April 17, 2024

SUBJECT: Response to *Interim Long Term Monitoring Plan for Groundwater and Surface Water*  
JCI/Tyco FTC PFAS, 2700 Industrial Parkway South, Marinette, WI  
BRRTS #02-38-580694

# Attachment A: Copy of Figure 10 from JCI/Tyco's Apr. 2023 SI Status Report with Proposed and Recommended New Well Locations Identified

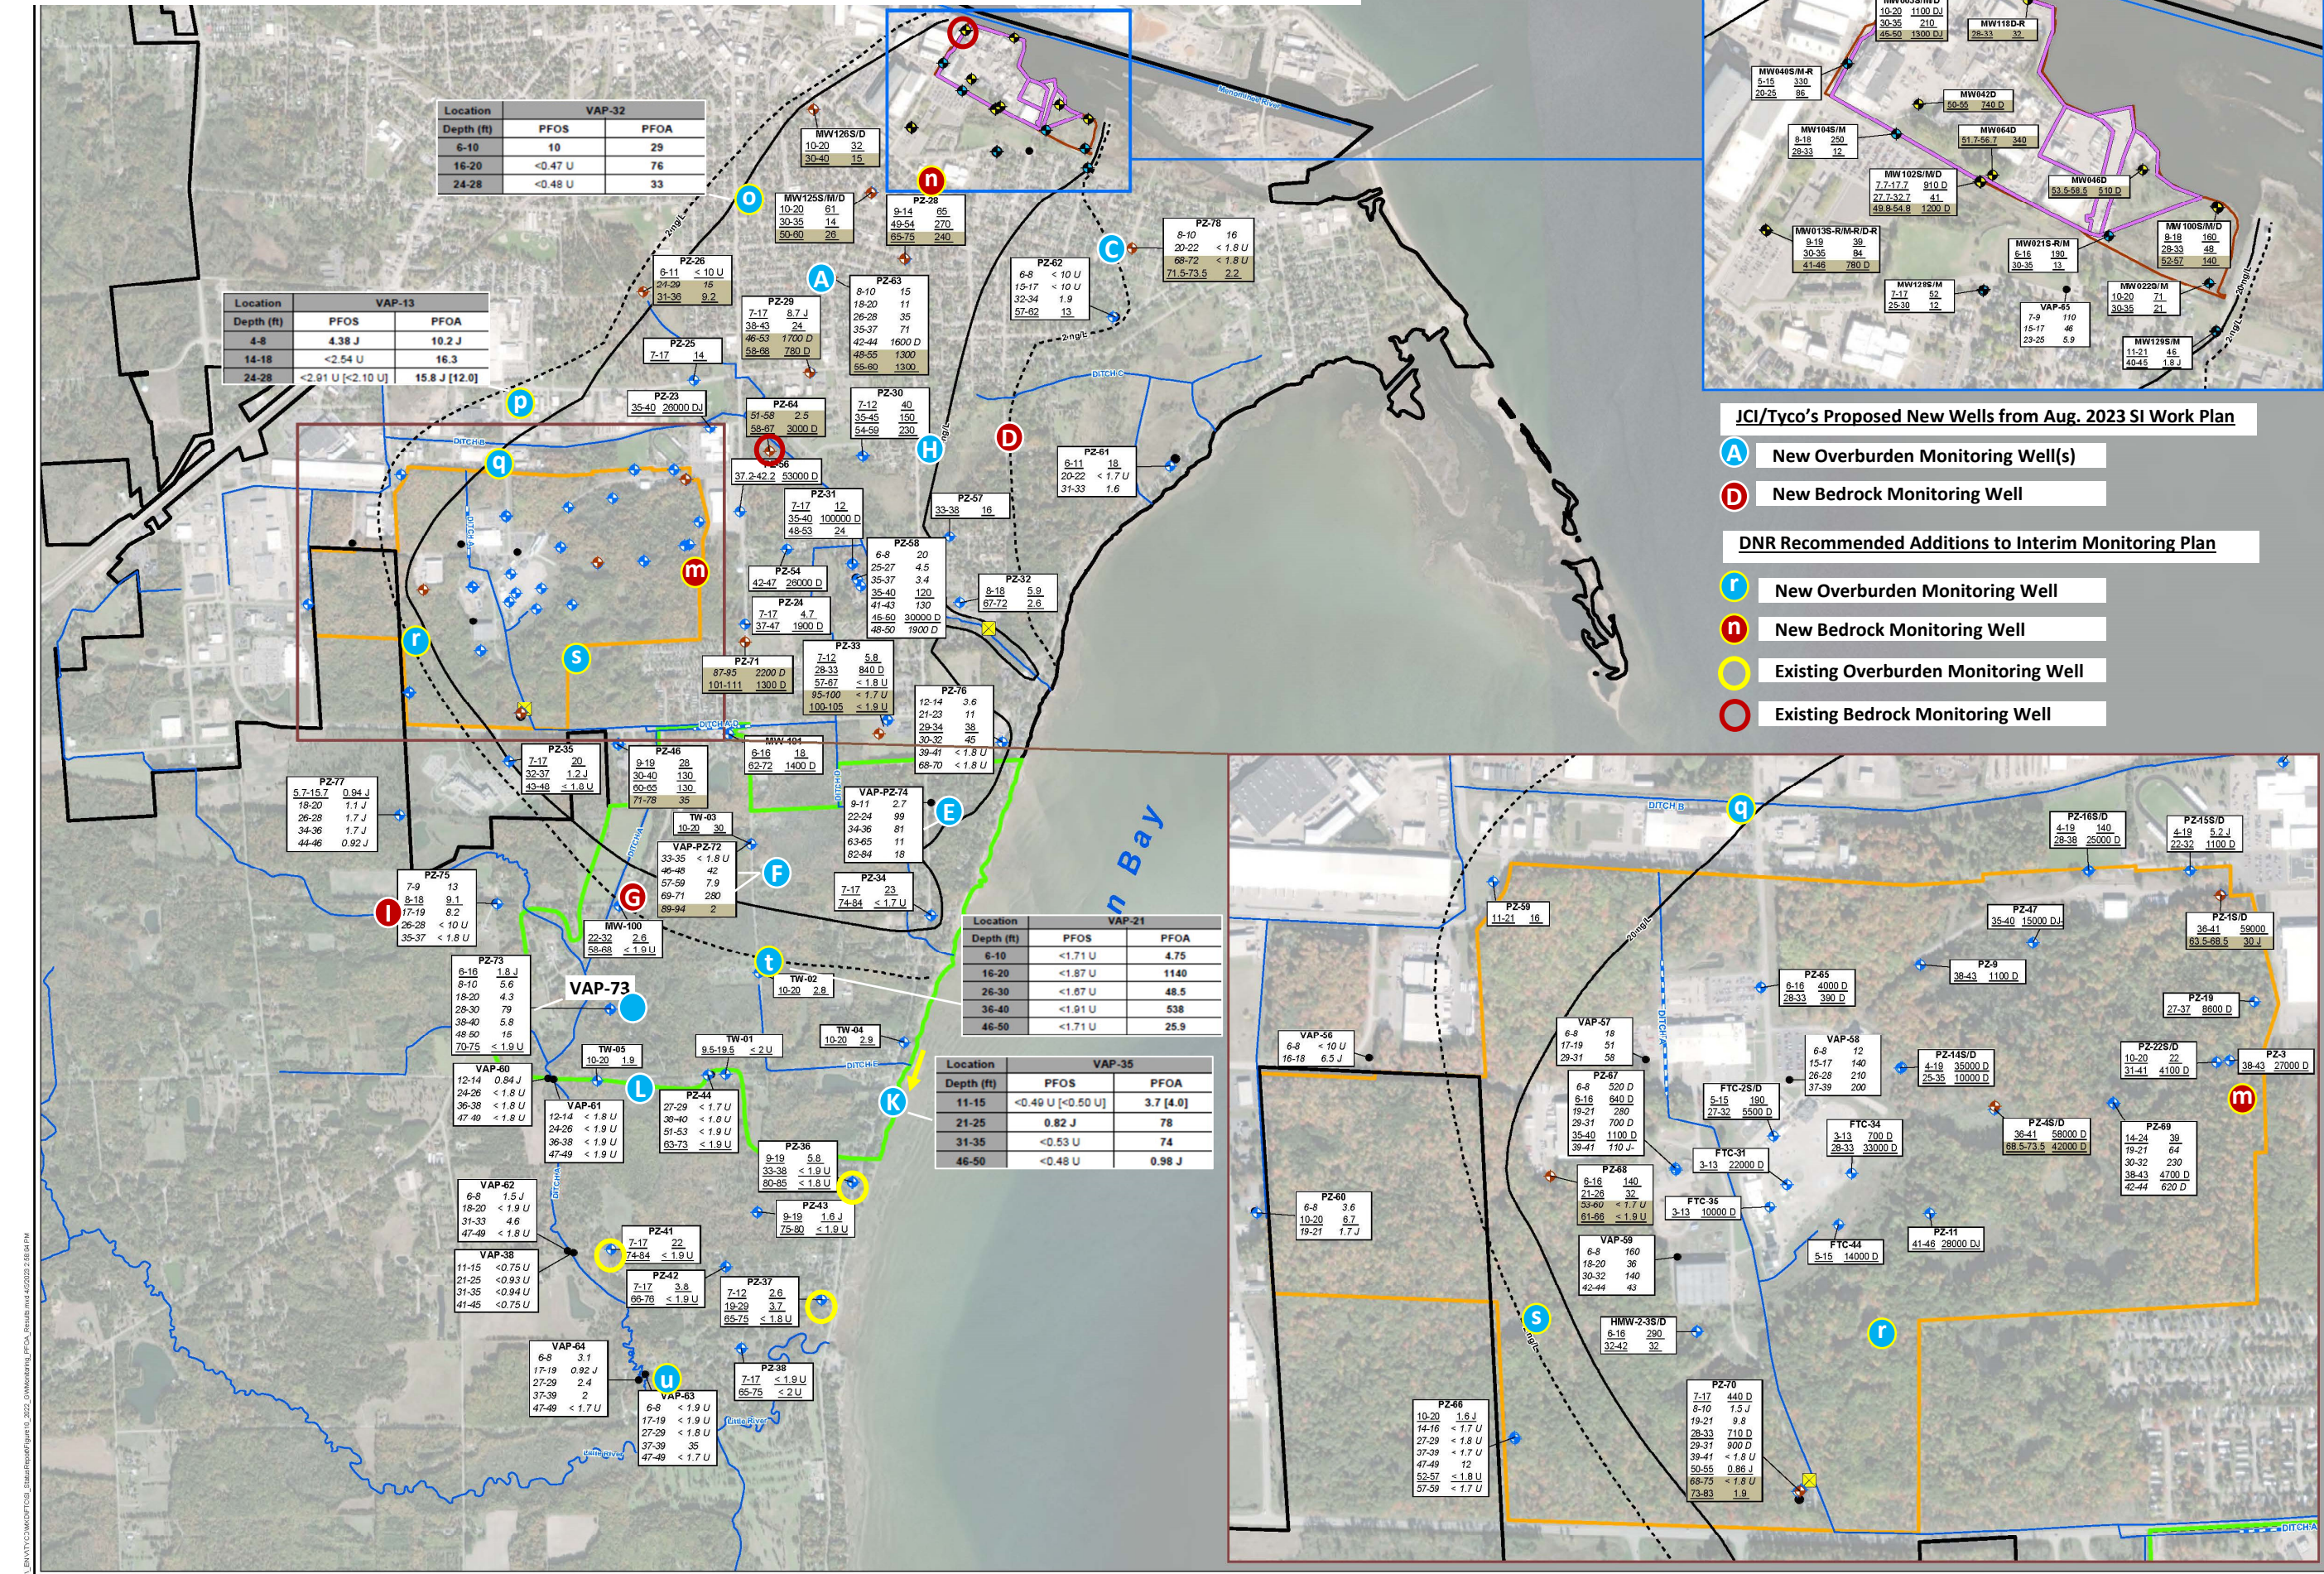
Monitoring Well Additions: The DNR recommends adding monitoring wells into the Interim Monitoring Plan, which are summarized in the **Attachment A Table and Figure**. This includes two existing bedrock monitoring wells and eight new monitoring wells in addition to the ones recommended above. The DNR also recommends adjusting the location of proposed monitoring well “K,” to be closer to vertical aquifer profile (VAP) sampling point VAP-35 (see **Attachment A Figure**).

Monitoring Well ID	Existing	New	Notes
“u”		x	Monitoring well at VAP-63 (37-39)
PZ-37-12 (or PZ-36-19)	x		Groundwater flow path from losing section of Ditch A
PZ-37-29	x		Groundwater flow path from losing section of Ditch A
PZ-41-17	x		Further evaluate cause and significance of PFAS

Monitoring Well ID	Existing	New	Notes
PZ-64-67	x		Not included in GETS monitoring plan
MW003D	x		Last monitoring point before Menominee River
“m”		x	Concentration and stability at FTC property boundary
“n”		x	Look for connecting flow pathway to Stanton Street

Monitoring Well ID	Existing	New	Notes
“o”		x	Stability at drawn boundary, see VAP-32 (16-20)
“p”		x	Stability at drawn boundary, see VAP-13 (4-16)
“q”		x	Stability at drawn boundary, b/w VAP-65 and Ditch B
“r”		x	Confirm drawn boundary, use VAP to select depth <sup>1</sup>
“s”		x	Concentration and stability at FTC boundary
“t”		x	Monitoring well at VAP-21 (deeper than 20’)
